Ref: Addendum #3  
Cherokee Service Area Interconnect and Booster Station Replacement  
R303231.08

Addendum #3 shall be incorporated into the Contract Documents for the above referenced project. The Addendum includes information for bidders, updated bid form, updated electrical sheets, technical information for the replacement building for the Cherokee Well House and water tank removal, update to Section 33 13 00, a fencing detail, and information on the existing irrigation well that will need to be plugged as part of the Cherokee Well House Rehabilitation.

UTILITY DETAIL SHEET  
 CHEROKEE SERVICE AREA  
 INTERCONNECT & BOOSTER  
 STATION REPLACEMENT  
 RUIDOSO, NEW MEXICO

PROJECT NO: R302231.08  
 DESIGNED BY: RDV  
 DRAWN BY: AJM  
 CHECKED BY: JDB  
 DATE: 08/18/16  
 WDR CHK:  
 SHEET: C-502

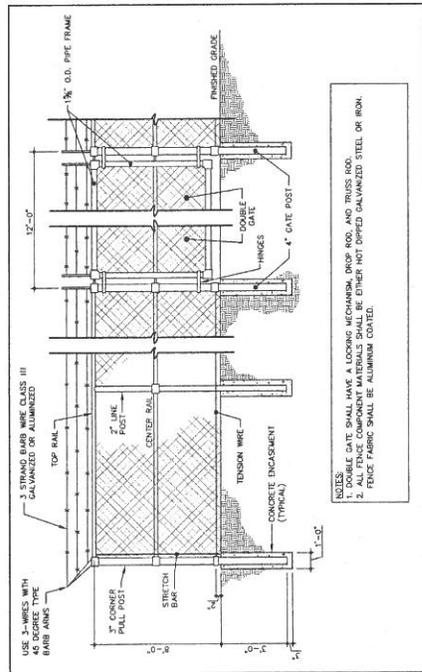
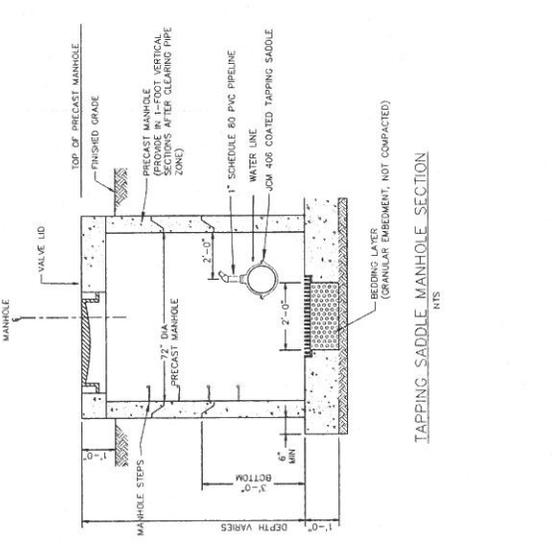
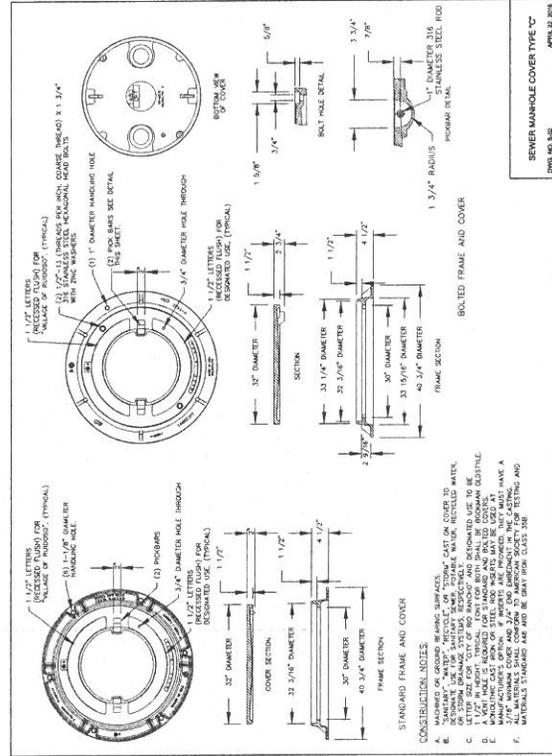
Attached: H-272 Declaration, C-410 Bid Form, Section 33 13 00, 33 16 13.12 and 02 53 20A, updated electrical sheets, Section 02 52 20A Well Pump House for Cherokee, and C-502 with a detail for chain link fence.

at _____ Dollars		
			and _____ Cents		
			per lump sum		
46	435	LF	Furnish and install chain link fence per detail, see sheet C-502, cip.		
			at _____ Dollars		
			and _____ Cents		
			per linear foot		
<b>BID SCHEDULE TOTAL AMOUNT: \$</b>					
<b>NMGRT @ 8.4375%</b>					
<b>PROJECT TOTAL AMOUNT: \$</b>

CONSTRUCTION NOTES:  
 1. GATE SHALL HAVE A LOCKING MECHANISM, DROP ROD, AND TRUSS ROD.  
 2. ALL FENCE COMPONENT MATERIALS SHALL BE EITHER HOT DIP GALVANIZED STEEL OR IRON.  
 3. FENCE FABRIC SHALL BE ALUMINUM COATED.
